Access Compliance Report

Public Rights-of-Way

Intersection ID: 9962	Main Street: LITTLE ROCK RD	Cross Street: N/A	Location:	E
ADA ID: 3F890AE4521E	Ramp Type: Para	Initial Pass/Fail: Pass	Overall Compliance: No	Severity Score: 17.5

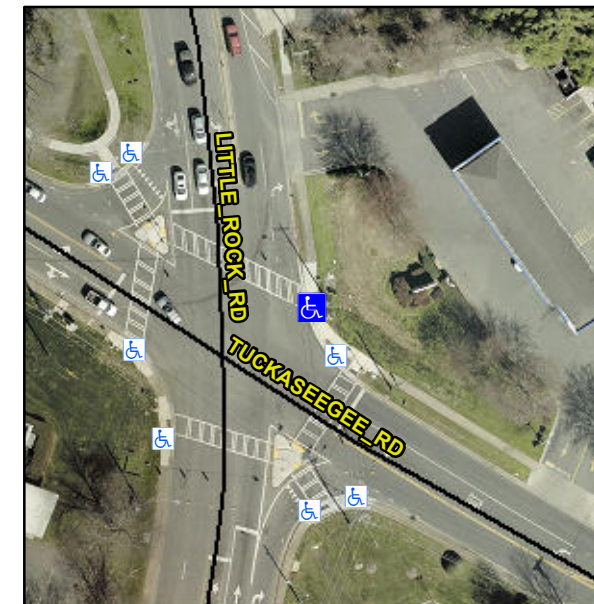
CURB LIP 1.5, LT RP < 5%, RT RP < 5%

R304.2.1, R304.5.3, R305, R302.7.2

Remove & Replace Entire Ramp.
Remove & Replace Gutter.
